**SUBJECT: Appeal of Decision of the Historic Preservation Commission
Concerning Property Located at 1780 Ridgewood Drive by Peggy
Hibbert**

I. 1780 Ridgewood Drive, Peggy Hibbert. Enclose front porch, build a small rear addition, replace windows, limewash the brick veneer, and replace the accessory building. 1246671

HIBBERT RESIDENCE
 1780 RIDGEWOOD DR
 ATLANTA, GEORGIA
 EXTERIOR ELEVATIONS
 - PRIMARY STRUCTURE

PRIMARY FRONT ELEVATION
 SCALE: 1/4" = 1'-0"

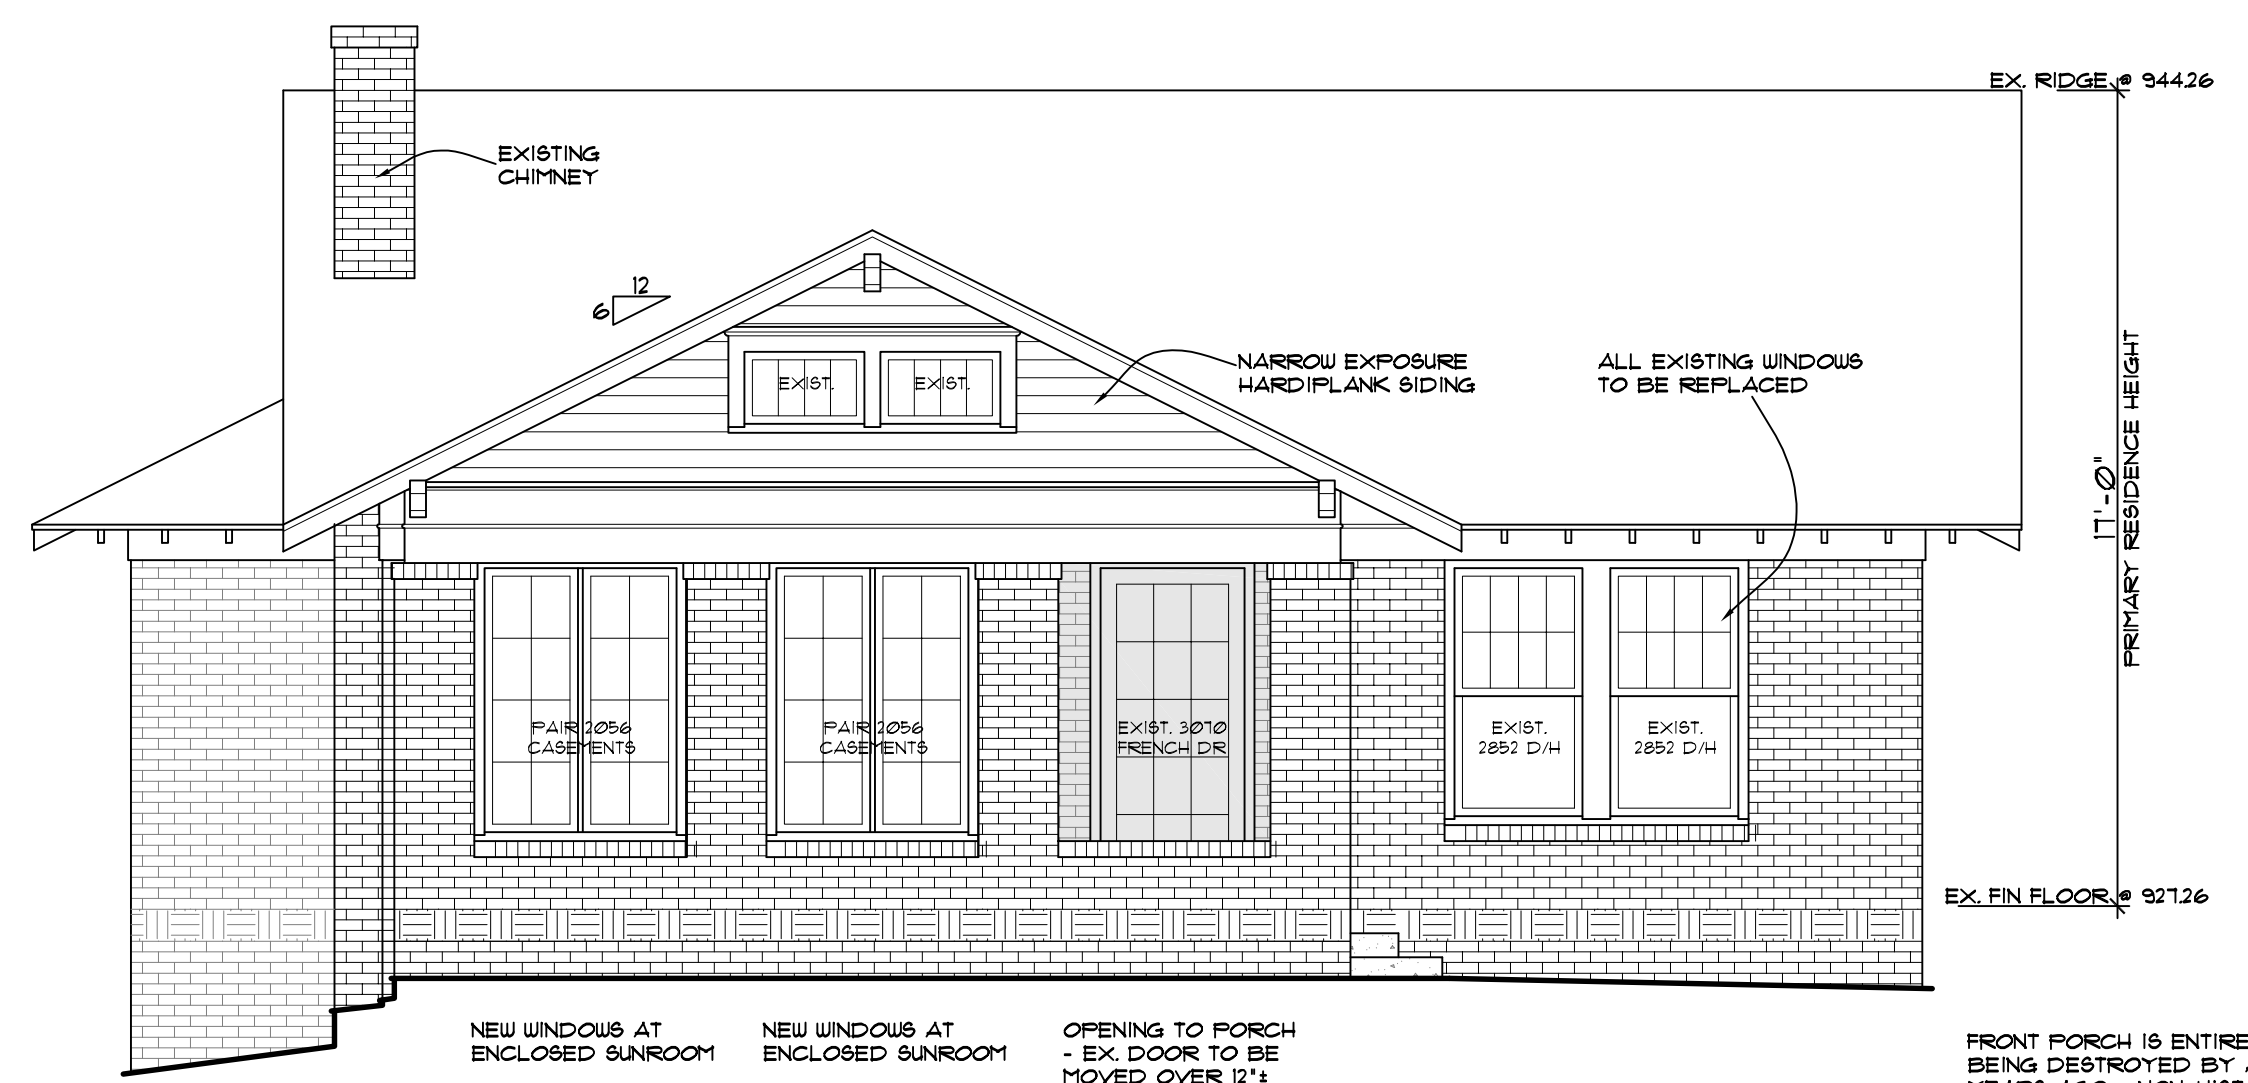
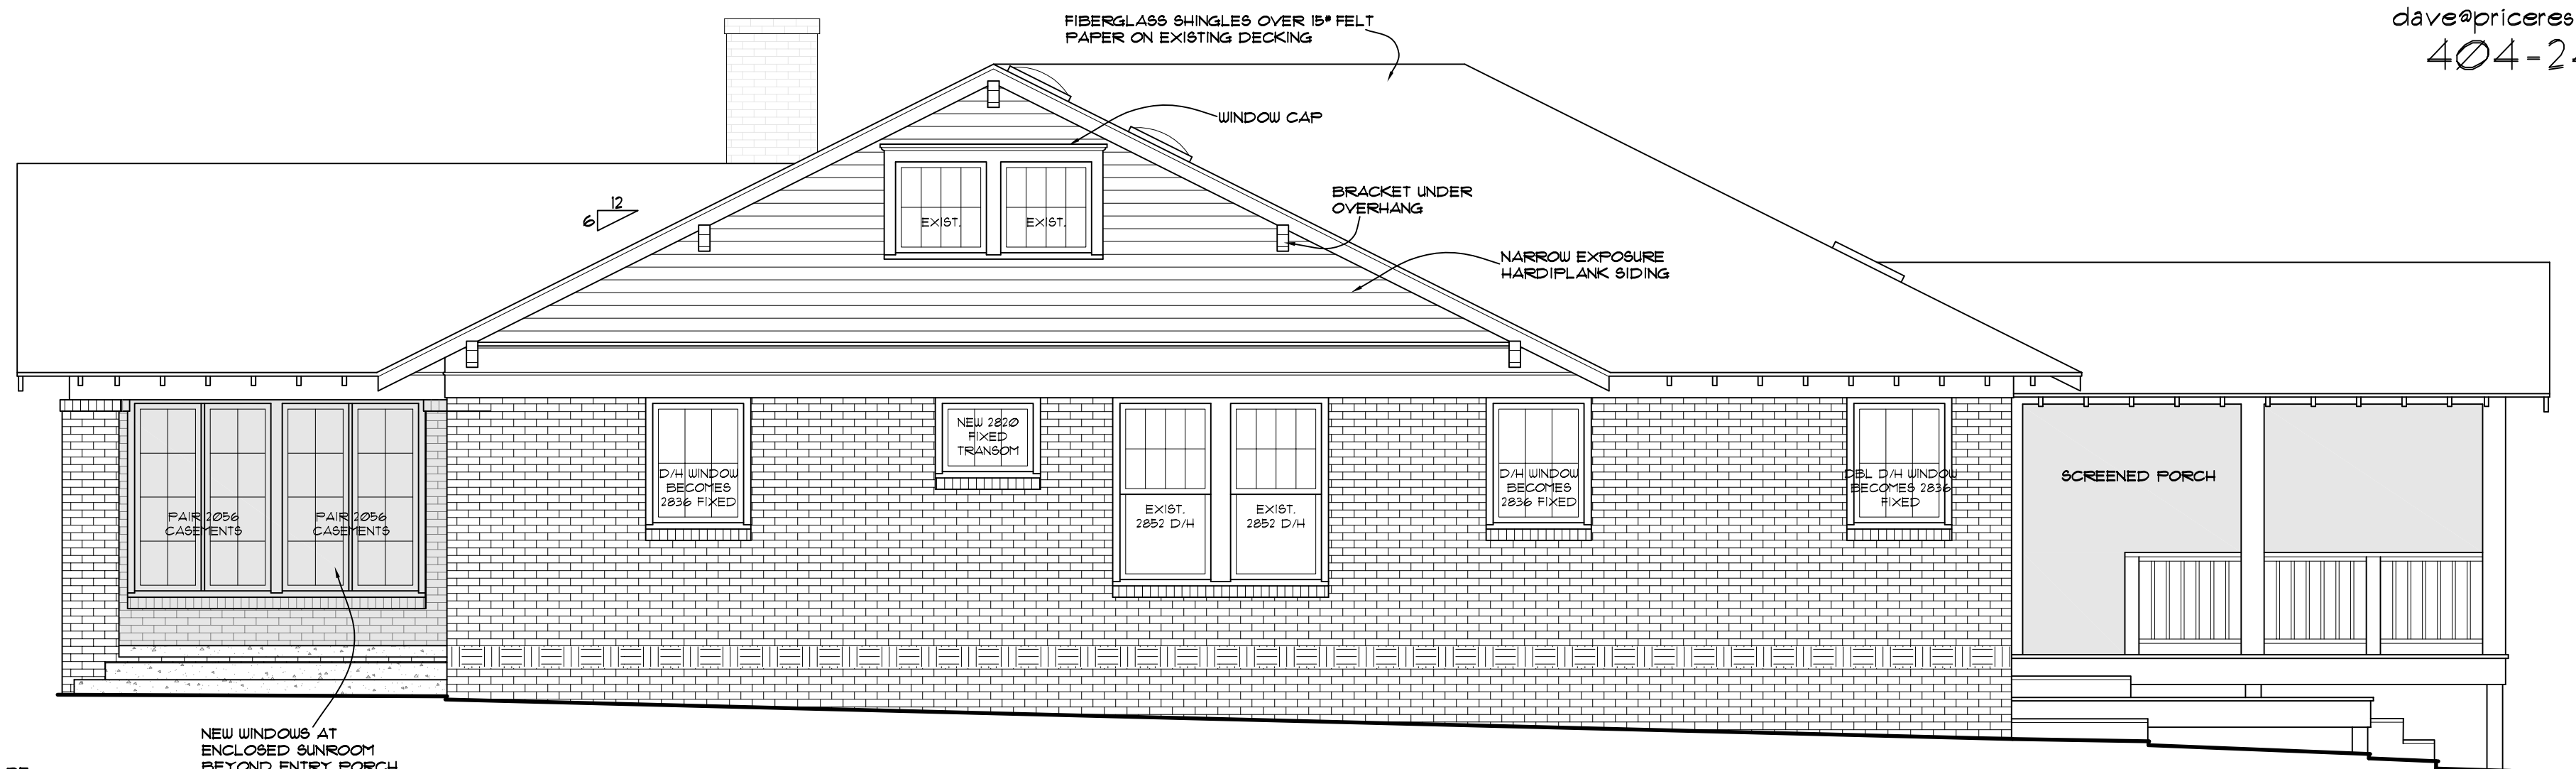
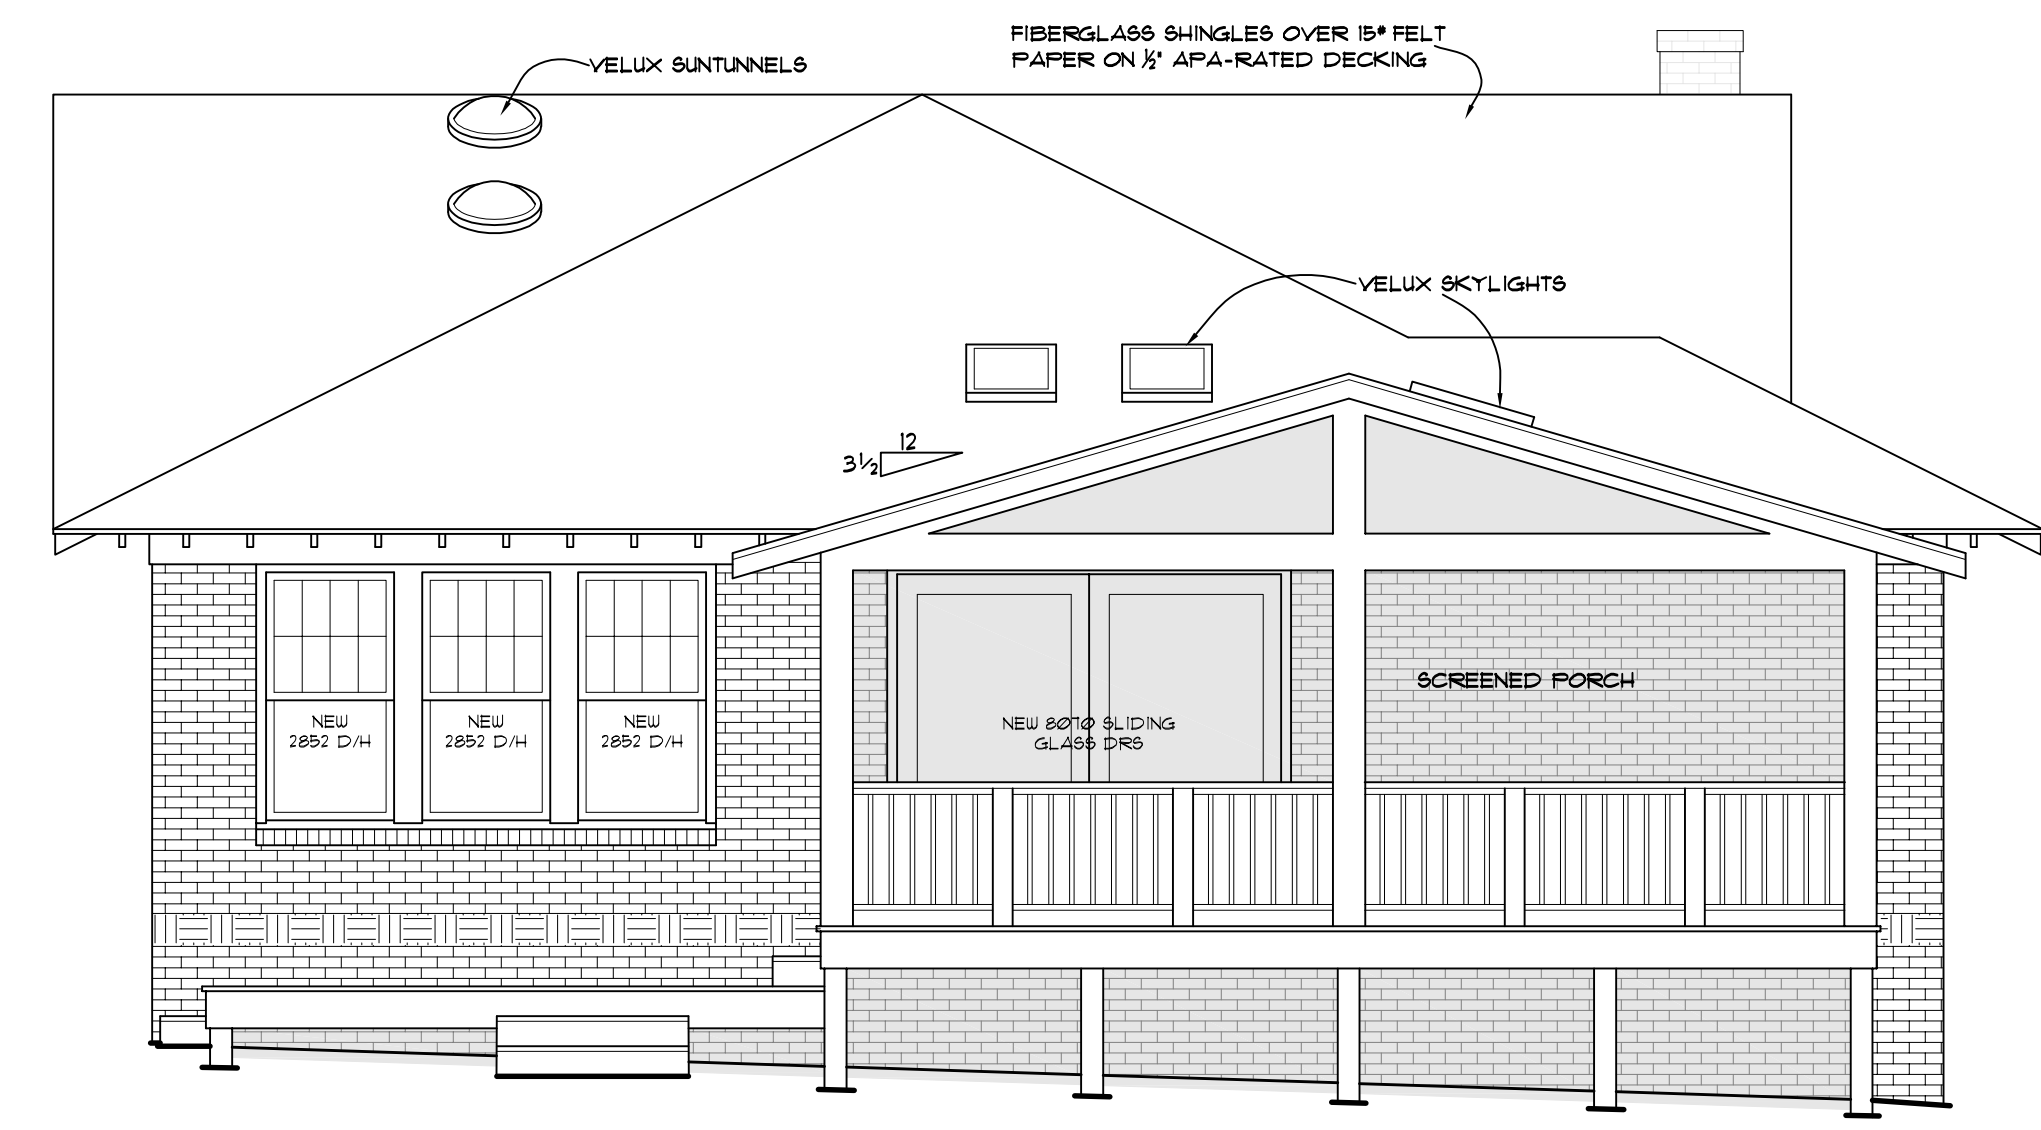
1) The only evidence in the record clearly establishes that the application for enclosure of the front porch met all relevant Guidelines. It was arbitrary for the HPC to find otherwise;

2) There was no evidence in the record as to what the original porch looked like. Therefore, reliance upon the unsubstantiated representations of staff that the original porch appeared as does the current porch was arbitrary and an abuse of discretion;

Replica? Staff recommended denial of the application based on Guidelines 6.1.3, 6.1.4, and 7.3.1. Staff noted that the front porch had been destroyed when a tree fell on it but stated that it had been replaced with an exact replica of the original. Appellant submits that this is where staff and thus the HPC in adopting the staff findings erred. **There is absolutely no evidence** in the record establishing what the “replica” or “the original porch” looked like. There is also no

1. **Deny.** The proposed enclosure of the front porch would not comply with guidelines 6.1.3, 6.1.4, and 7.3.1 and would have a substantial adverse effect on the house and the historic district. Although a reconstruction, the porch is a replica of the original and for the purpose of applying guideline 6.1.3, should be treated as if it were original.

The proposed enclosure of the front porch, the use of brick on the rear addition, reduction in size of the windows flanking the chimney, relocation and replacement of the front door, and limewashing the house were not approved.
